PD Modification Application: MM 25-1242

Zoning Hearing Master Date:

November 17, 2025

Introduction Summary:

8.2 Proposed Site Plan (Full)

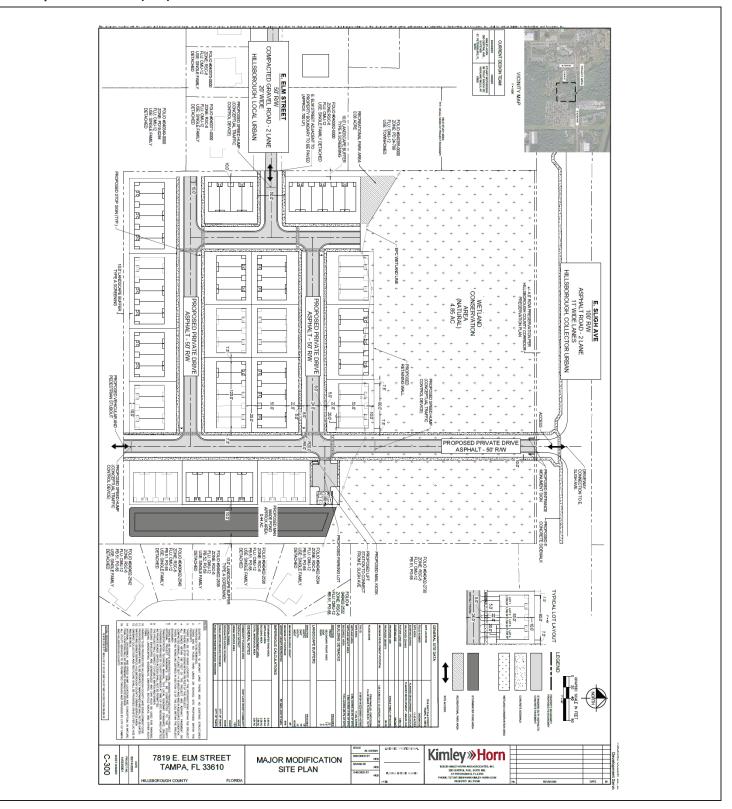
Prior to certification, the applicant shall make the following revisions to the PD site plan:

1. Update the general site data table to note that the 0' setback is to the lot line, not the PD boundary and that indicated 10' on the lot detail is actually the buffer area.

ELM STREET
ROADWAY IMPROVEMENTS
TYPICAL SECTION
(LOOKING EAST)
DESIGN SPEED 25 MPH

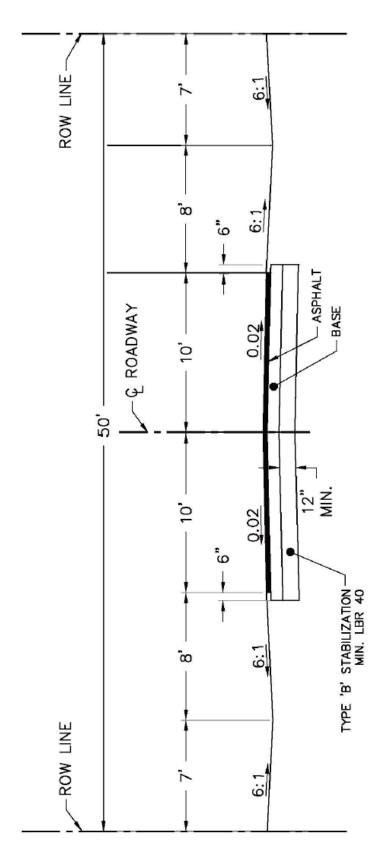
3. No sidewalks are being provided along Elm Street as the internal project roadways will provide sidewalks and pedestrian/vehicular connection to Sligh Avenue. As part of this development, a sperate Design Exception for Sligh Avenue will provide for a sidewalk along the south side of Sligh Avenue from Orient Road to the eastern project boundary.

The proposed typical section is shown in Figure 2.

Based on the information provided by the applicant, this request is: Disapproved _____ Approved with Conditions X If there are any further questions or you need clarification, please contact Sheida L. Tirado, P.E.

The County Engineer has reviewed zoning modification application # 25-1242 and determined the changes to be de mimimis. As such, the previous approval shall stand.

Figure 2: Proposed Western Typical Section

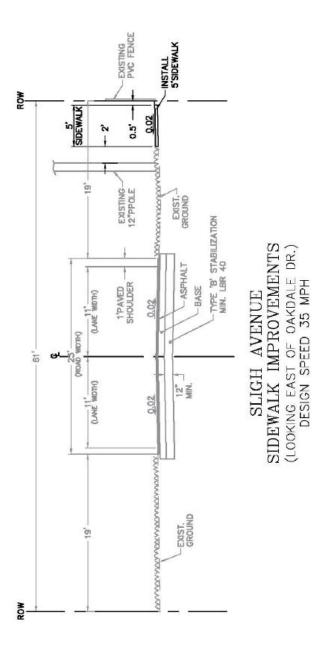
- 1. The existing ROW along Sligh Avenue is approximately 61.5 feet. The typical TS-7 section for a rural, two-lane undivided roadway requires a minimum of 96 feet of ROW with 12-foot lanes, 5-foot paved shoulder, open drainage, and a 5-foot sidewalk.
- 2. The request is to maintain the existing 11-foot travel lanes and relatively flat shoulder/open drainage. The missing segments of the 5-foot sidewalk on the south side of the road will be completed which will add approximately 350 linear feet of sidewalk. Based on Table 210.2.1 of the FDOT Design Manual, the 10-foot travel lanes are identified as acceptable.

The proposed Western typical section is shown in Figure 2 and the proposed improvements are shown in Figure 3.

If there are any further questions or you need clarification, please contact Sheida L. Tirado, P.E.

The County Engineer has application # 25-1242 r has reviewed zoning modification and determined the change to be de mimimis. As such, the previous approval shall

Figure 4: Proposed Eastern Typical Section

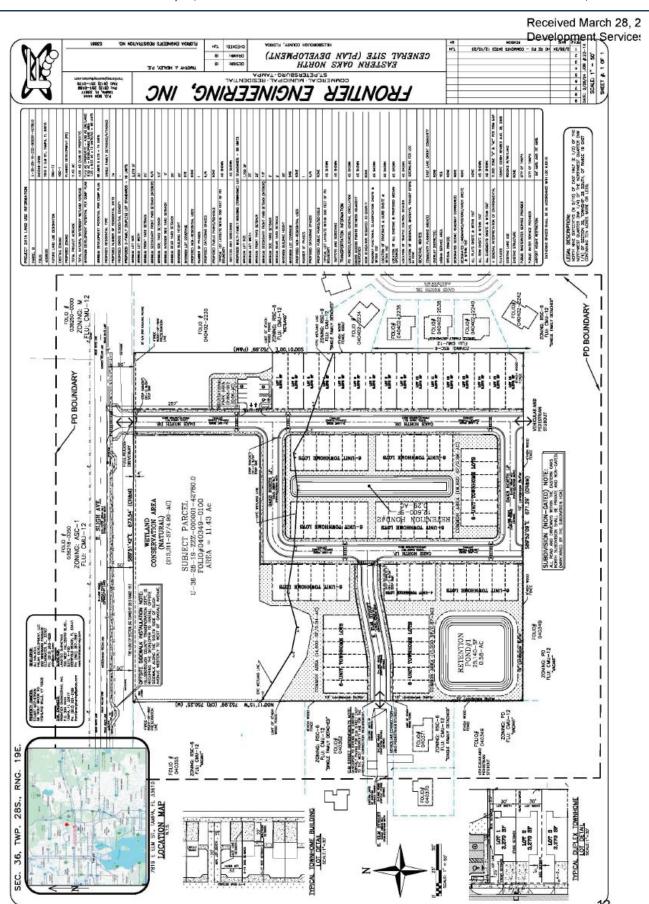
- 1. The existing ROW along Sligh Avenue is approximately 100 feet, however, there is an existing wetland within the existing ROW along both sides of the roadway. The typical TS-7 section for a rural, two-lane undivided roadway requires a minimum of 96 feet of ROW with 12-foot lanes, 5-foot paved shoulder, open drainage, and a 5-foot sidewalk.
- 2. The Eastern Section currently has 11-foot travel lanes in approximately 100 feet of right of way. The request is to maintain the existing 11-foot travel lanes and add approximately 1,300 linear feet of 5-foot sidewalk on the south side of the roadway, with a 6-foot grass strip on the south side and a 2-foot grass strip behind the sidewalk. Due to ROW constraints and existing conditions, the slope to the wetland may exceed to 1:4 side slope but will not exceed 1:2.

The proposed Eastern typical section is shown in Figure 4. Please do not hesitate to contact us if you have any questions or require any additional information.
